**Walter Williams - RE: Petition #1768r2 - Elevation Measurements**

## Walter Williams - RE: Zoomed-In view of Awning - 1400 Woodward

SHT 2 OF 2	SITE PLAN ENCROACHMENTS	1400 WOODWARD HOTEL 1400 WOODWARD AVE. DETROIT, MI	PREPARED FOR: <b>KRAEMER DESIGN GROUP</b> 1420 BROADWAY DETROIT, MI 48226	 www.MannikSmithGroup.com	TECHNICAL SKILL. CREATIVE SPIRIT.	65 CADILLAC SQUARE SUITE 3311 DETROIT, MI 48226 TEL: 313.961.9500 FAX: 313.961.9509	NO. 1 2	DATE 08/30/2018 09/18/2018	BY MSG MSG	DESCRIPTION REVISIONS TO ENCROACHMENT SITE PLAN REVISIONS TO ENCROACHMENT SITE PLAN
						PROJECT DATE: 02/06/2018 PROJECT NO.: K1880004 DRAWN BY: BLA CHECKED BY: DAR

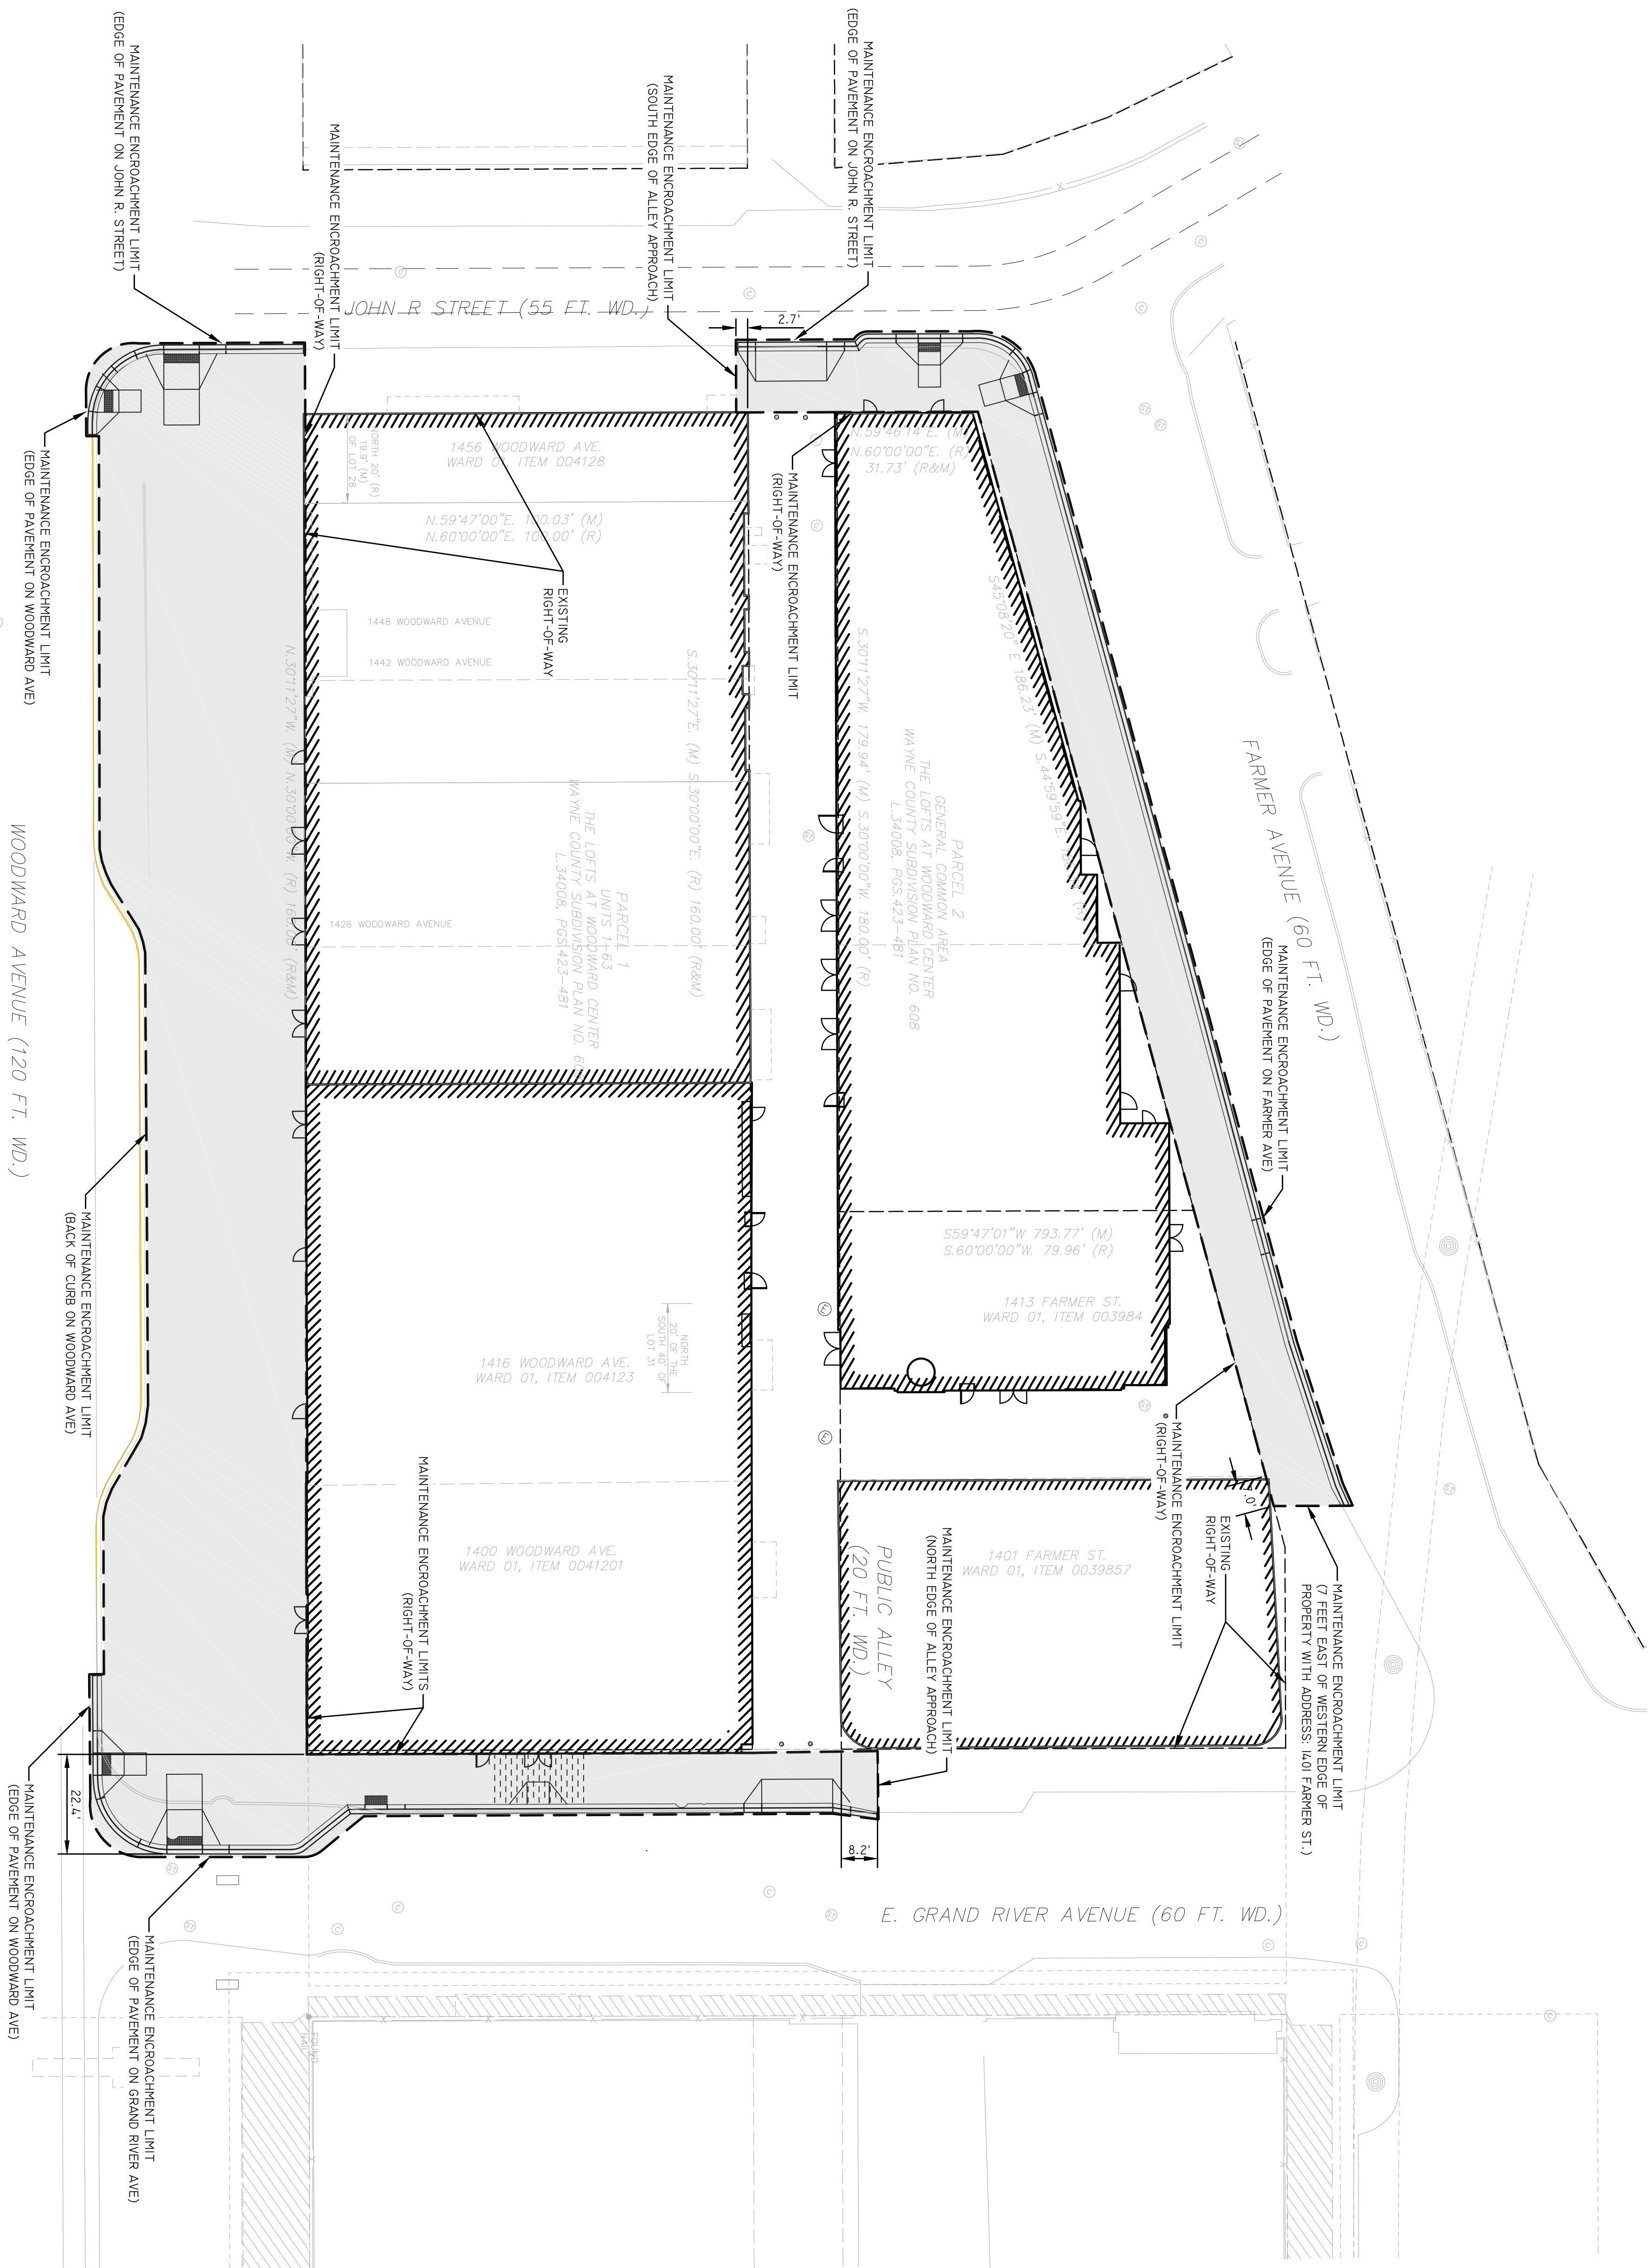
After reviewing the documents that you have provided, do you have any documentation on any encroachments that will be below ground?

The second page for encroachments is primarily for all items at grade and below. This will include all the paving of the walks that are paver bricks, grates for the trees, the portion of landscaping below ground and irrigation for the landscaping.

Specifically pave bricks and their base material are located in all the shaded areas shown in the second page. Attached is the site plan showing the location of landscaping, there is no plan showing underground irrigation to the landscaping.
